Swanzey Planning Board Agenda
April 23, 2026
6:00 PM

Memorandum – Office of Planning and Economic Development

RE: Site Plan Review Application #26-005 – Dillant-Hopkins Airport Solar Arrays

SOUTH END (screening is shown to be consistent along Route 32):

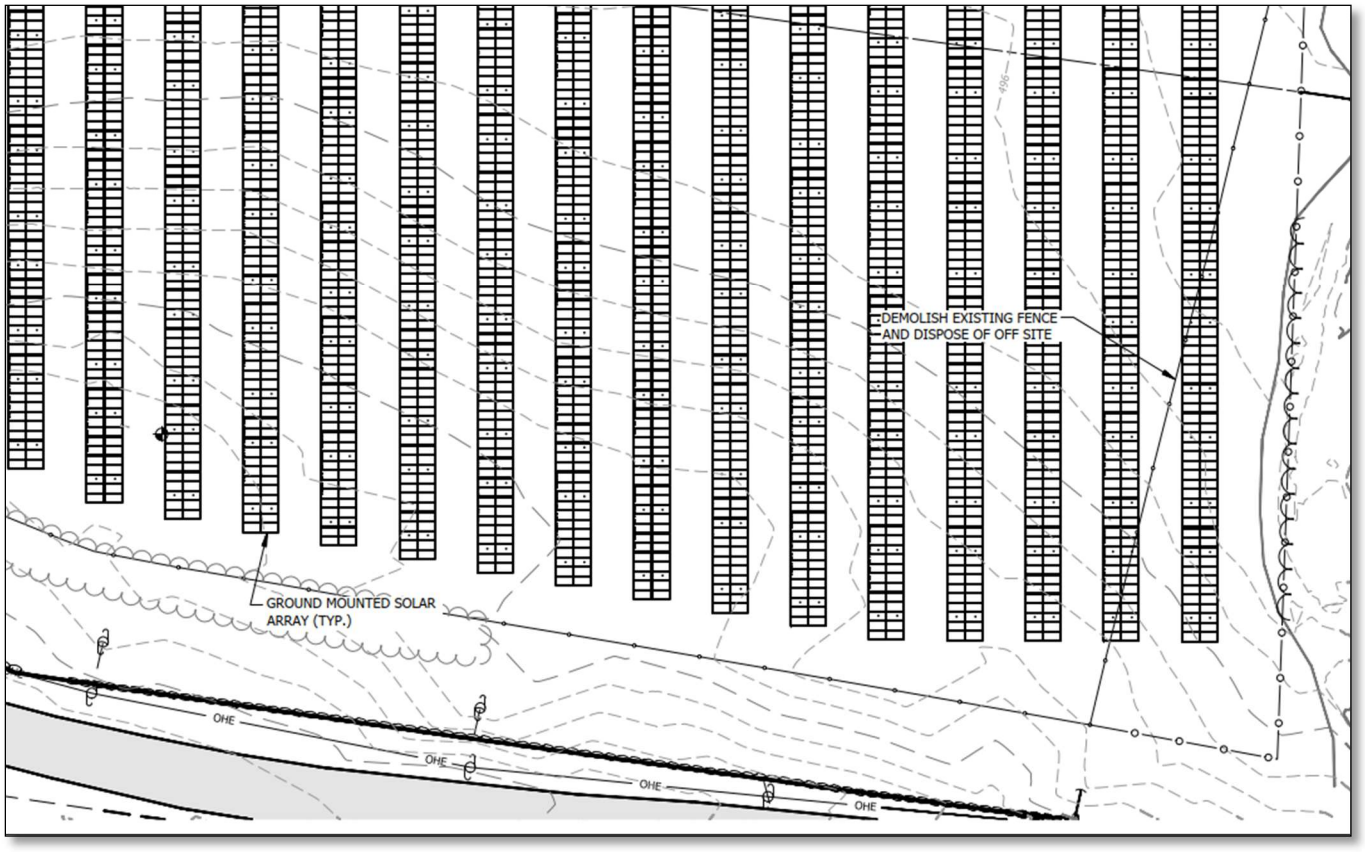
The applicant has addressed all site plan review regulations (pages III-1 through III-3), and staff confirms the proposal meets all base requirements. While there is no critical feedback, we recommend discussing **additional screening for Subarray #1**. The current plan may be insufficient at the **northern end** of the solar array, where existing and proposed buffers are thinnest. Please see the screenshots below for reference:

NORTH END (screening is shown to stop, leaving nine (9) rows of solar arrays unscreened):

1. Screening should be extended north along Route 32 for Subarray #1.
2. Planning board should discuss future possibilities to utilize this resource once the City of Keene reaches 100% renewable energy. Could a partnership be possible?
